Remarks

The following remarks are responsive to the Office Action dated July 15, 2004. Applicants respectfully request the Examiner's reconsideration of the present application as amended.

Fig. 2B

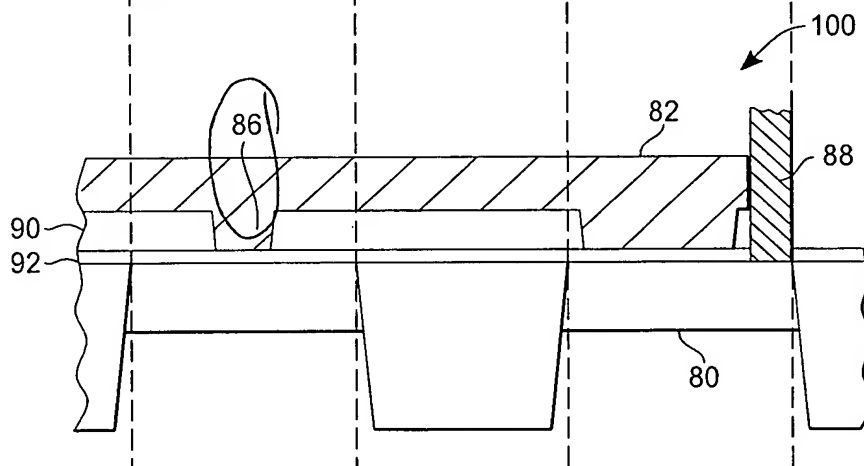
Figure 2B has been amended to improve clarity.

Fig. 2C

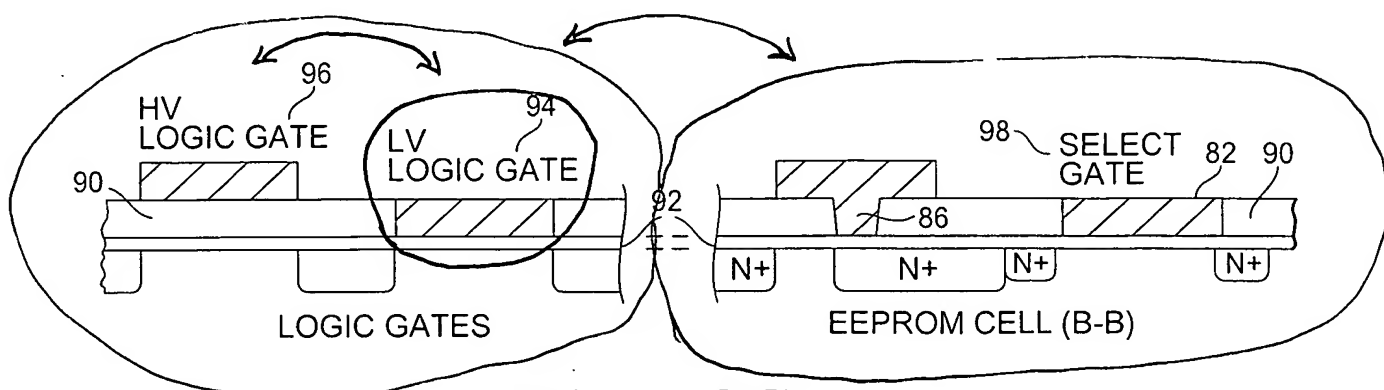
Figure 2C has been amended to improve consistency with the drawings in Figures 3A and 3B. The LOGIC GATES and EEPROM CELL drawings in Figure 2C have been switched or reversed to better correspond with the cross-sectional views presented in Figures 3A and 3B. In addition, the select gate in Figure 2C has been amended to correspond to the drawings in Figures 3A and 3B. No new matter has been added.

Fig. 3A

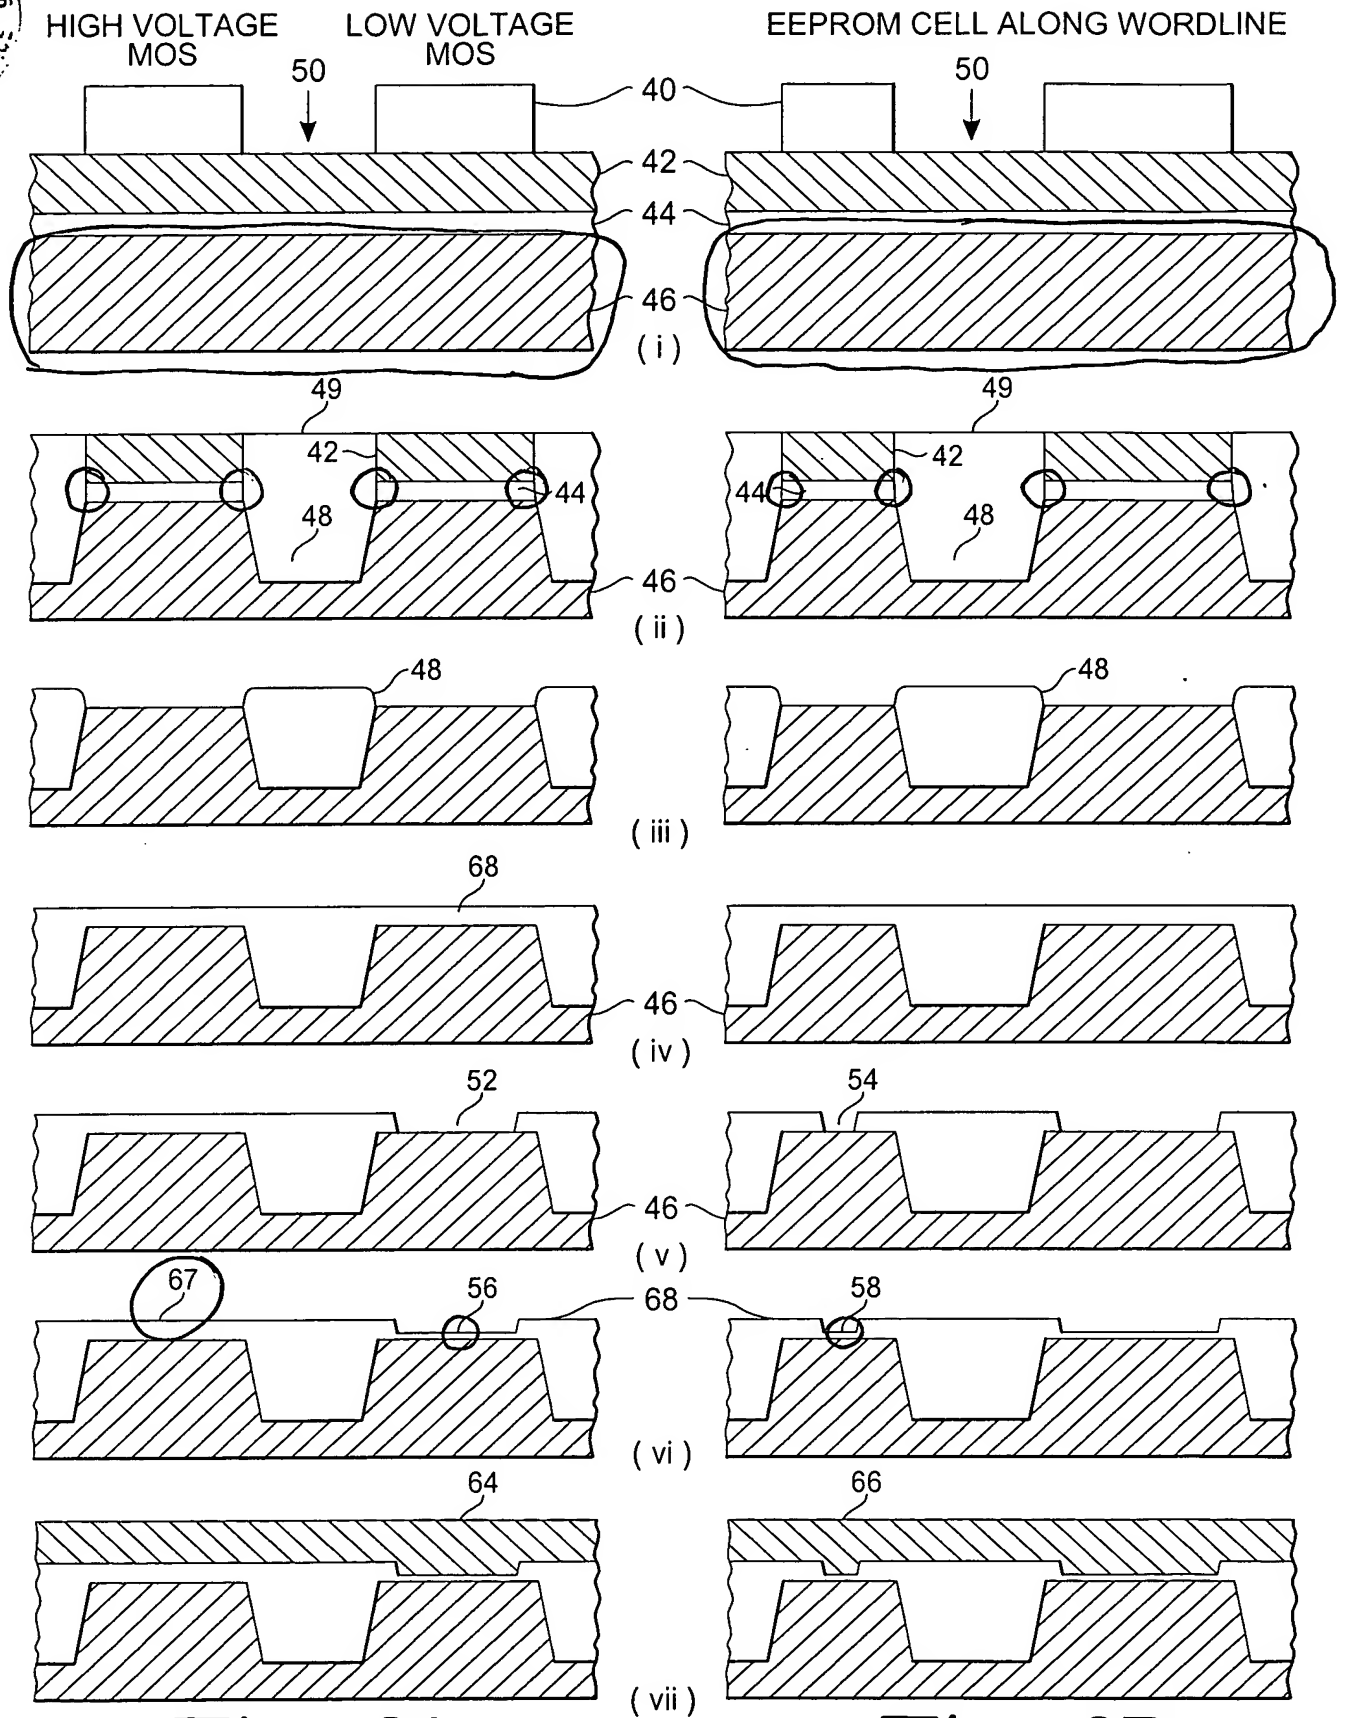
The drawings have been objected to under 37 CFR § 1.83(a). In Figure 3A (vi) a reference 67 has been added, and the specification has been amended to illustrate and describe exemplary first, second, and third device areas. No new matter has been added. Applicants believe that the amendment to Figure 3A and the specification now provides proper antecedent support for independent claim 1 and the other claims, and respectfully request withdrawal of the drawing objection.

Figures 3A (ii) and 3B (ii) have been amended for clarity. No new matter has been added.
